WELL API NO.  
**30-045-07658**

**BP America Production Company respectfully requests to P&A the subject well**

## **GCU 170-DK Plug & Abandon Regulatory Procedure**

**Subject:** GCU 170-DK: Request to P&A Wellbore

## Proposed WBD

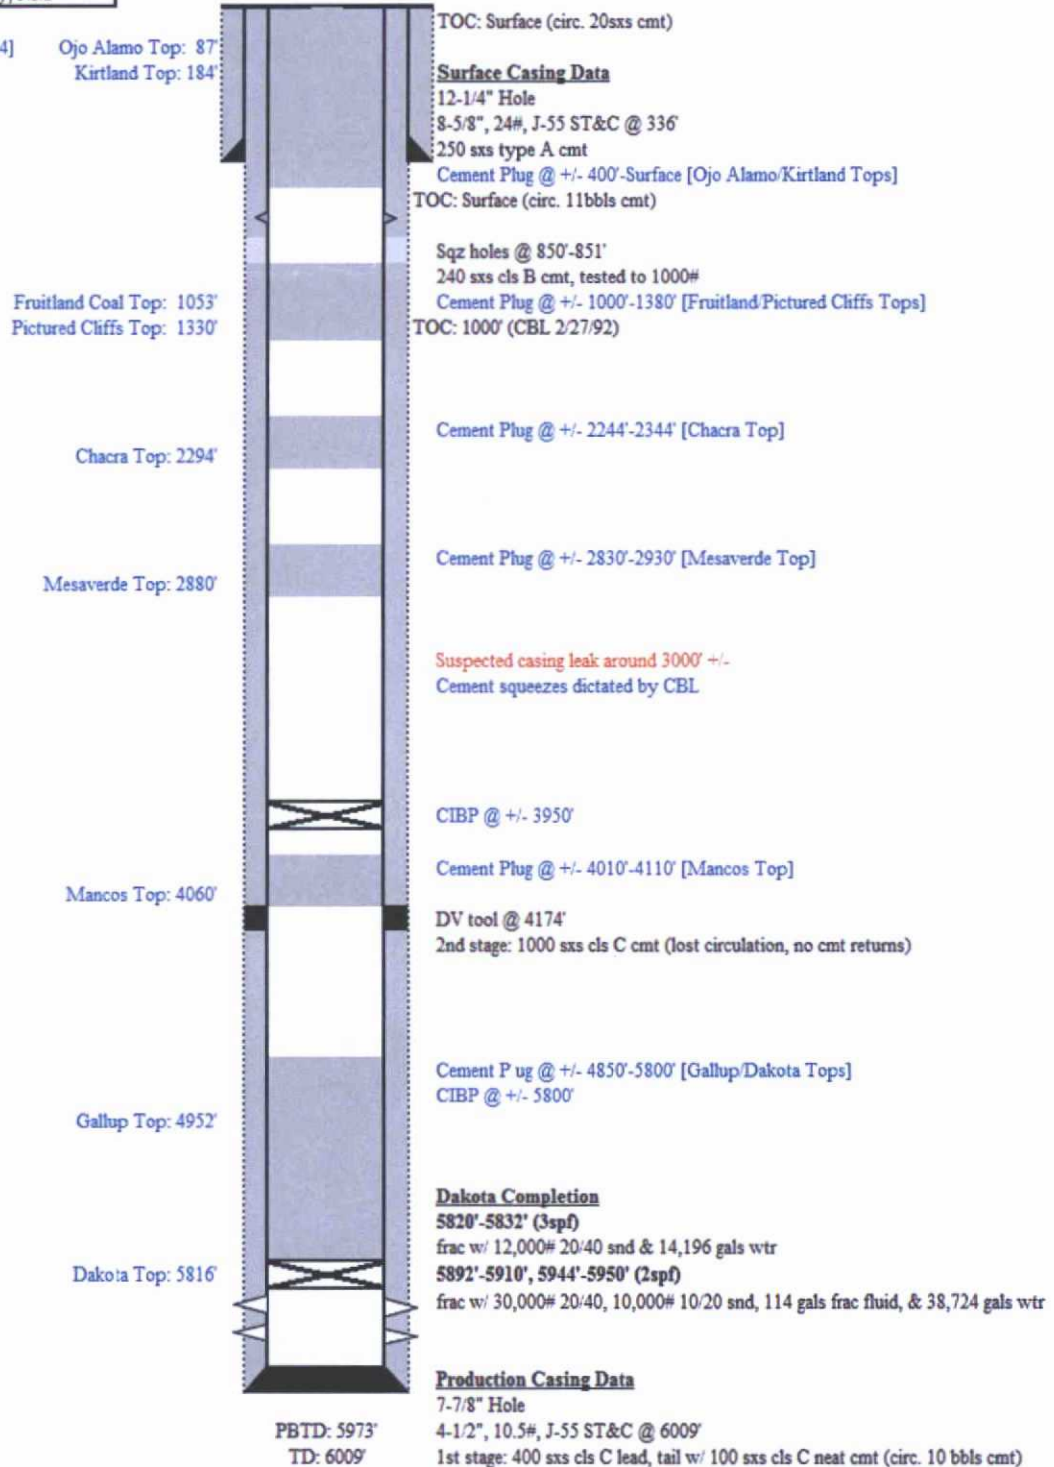
- a. Contingency – set cmt retainer @ +/- 2930' prior to spotting cmt if unable to balance plug
  - b. WOC, Tag plug if required
18. PU tbg to 2344'
19. Spot cmt plug @ +/- ~~2244'-2344'~~ **2372'-2472'** (Chacra Top @ ~~2294'~~ **2422'**)

- a. WOC, Tag plug if required
20. PU tbg to 1380'
21. Spot cmt plug @ +/- 1000'-1380' (Fruitland Top @ ~~1053'~~ **1092'**, PC Top @ 1330')
  - a. WOC, Tag plug if required

I made a few minor changes in the written procedure in red. Other than the changes everything looked good.

## Proposed WBD

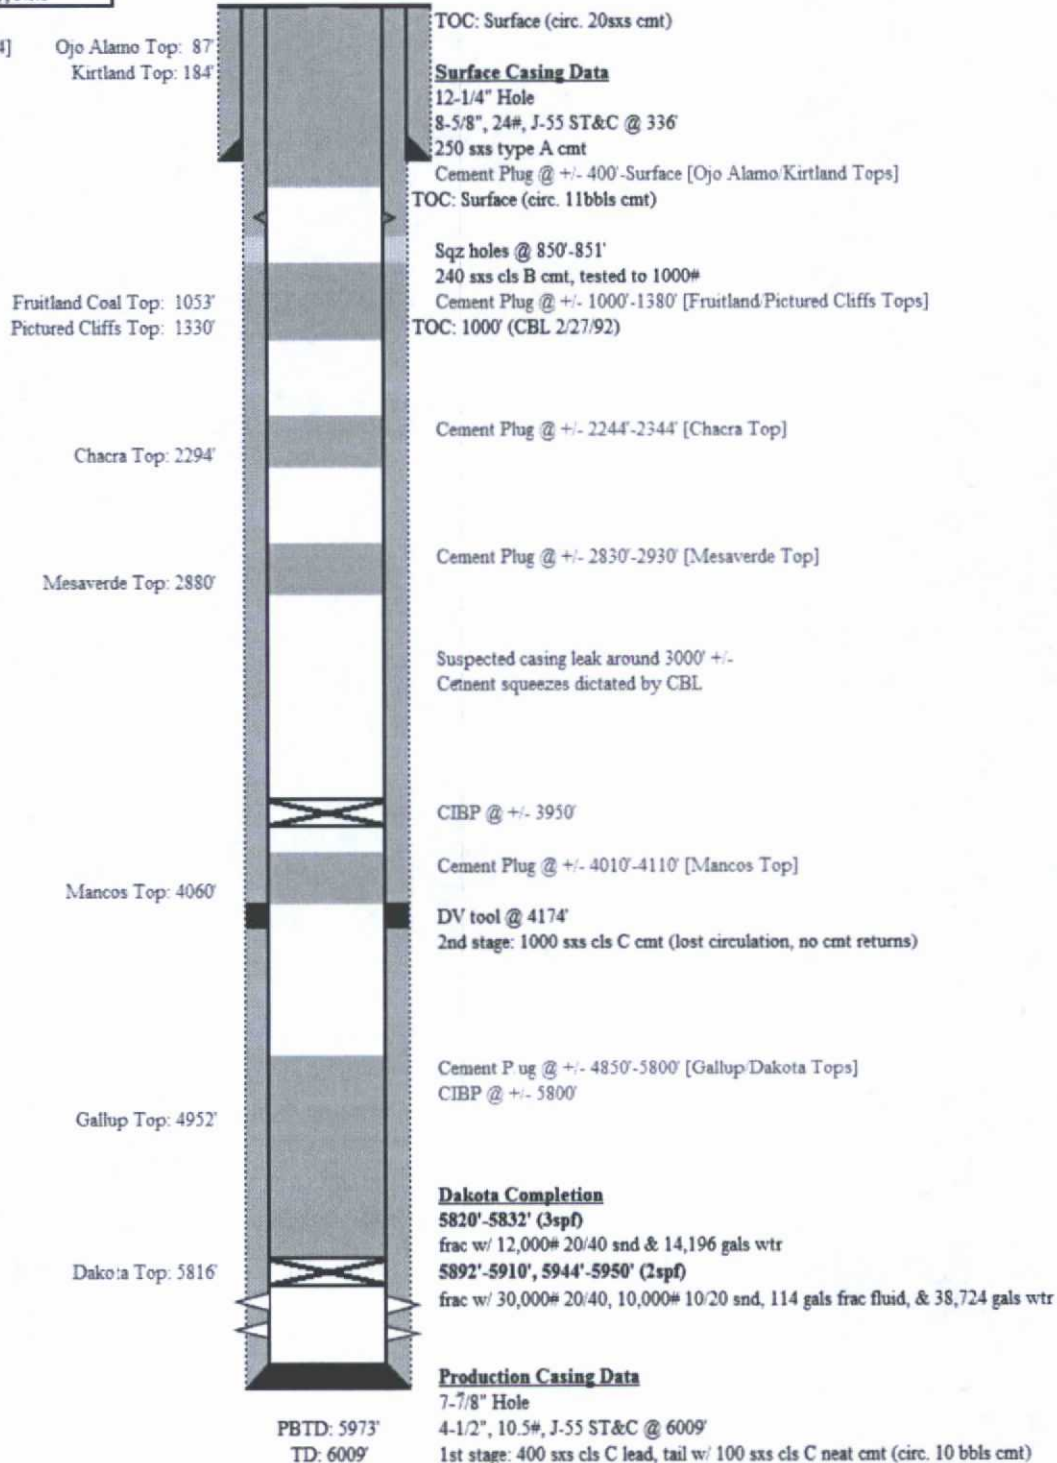
- a. Contingency – set cmt retainer @ +/- 2930' prior to spotting cmt if unable to balance plug
  - b. WOC, Tag plug if required
18. PU tbg to 2344'
19. Spot cmt plug @ +/- 2244'-2344' 2372'-2472' (Chacra Top @ 2294' 2422')

- a. WOC, Tag plug if required
20. PU tbg to 1380'
21. Spot cmt plug @ +/- 1000'-1380' (Fruitland Top @ 1053' 1092', PC Top @ 1330')
  - a. WOC, Tag plug if required

I made a few minor changes in the written procedure in red. Other than the changes everything looked good.

# **Proposed WBD**

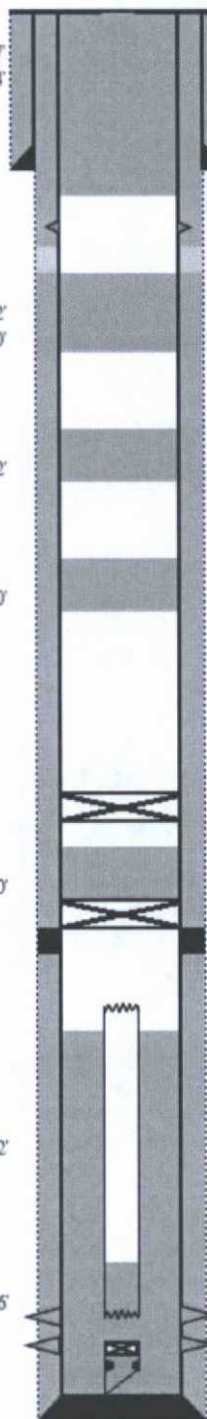
We have run into an issue with the lockdown pins on the wellhead. Due to the seal configuration of tubing head and condition of the lockdown pins, we believe that if we nipple down the tree or attempt to remove the lockdown pins in order to pull the tubing hanger, we risk losing containment of the casing through the tubing hanger seals and/or lockdown pin ports.

- Use coiled tubing to spot initial Dakota plug with tubing still in place
- Perforate tubing above top of cement plug
- Circulate kill weight fluid into casing in order to kill well long enough to replace the tubing head
- Once tubing head is replaced, continue with originally planned procedure with modified bottom plug

Thank you for your quick response. One step that I failed to request dispensation from is setting the CIBP at 3950'. Since we will not be hole-hunting with a packer we do not feel setting this plug is necessary. Additionally, I would like to request a slight change on the Mesa Verde cement plug. I think that we run the risk of covering the hole in the casing if we spot cement on top of the CIBP at 2930'. I would like to set the CIBP at 2930' and set the cement retainer at 2765' without spotting cement. We would then squeeze cement behind casing through the retainer and spot cement on top. Below is the step-by-step procedure I propose.

- 1) Set cement retainer and spot Mancos cement plug as previously agreed upon
- 2) Set CIBP at 2930'
- 3) Set cement retainer at 2765'
- 4) Squeeze 100' of cement plus 100% excess below retainer and behind casing
- 5) Spot 100' of cement plus 50% excess on cement retainer
- 6) Continue with P&A as previously agreed upon

- Based on CBL/CCL we believe the hole in the casing to be located at 2792'. As a result, we find it unnecessary to hunt for the hole with a packer.
- Set CIBP at 2930' to cover the Mesa Verde

- Spot 100' cement on CIBP
- Set cement retainer at 2765'
- Squeeze 100' of cement plus 100% excess behind casing
- Spot 50' cement plug on top of retainer

- Perforate casing at 2472' in the Chacra
- Set cement retainer at 2442'
- Squeeze 100' of cement plus 100% excess behind casing
- Spot cement plug from 2442'-2372'. Note: the depth of the Chacra top on the approved procedure was incorrect. The correct Chacra top is 2422'.

- Perforate casing at 1350' in the Pictured Cliffs
- Set cement retainer at 1330'
- Squeeze 340' of cement plus 100% excess behind casing.
- Spot 340' of cement plus 50% excess on top of cement retainer to cover the Fruitland and Pictured Cliffs

You have approval to proceed. Please notify us when you plan to start.

You do not need to set the CIBP at 3950'. However you will still need to spot a cement plug on top of the CIBP at 2930' to ensure the cement isolates the top of the Mesa Verde formation. This is because if there are holes above the formation top the cement will go out them instead of going down to cover the formation top.

You have our approval to continue as proposed.
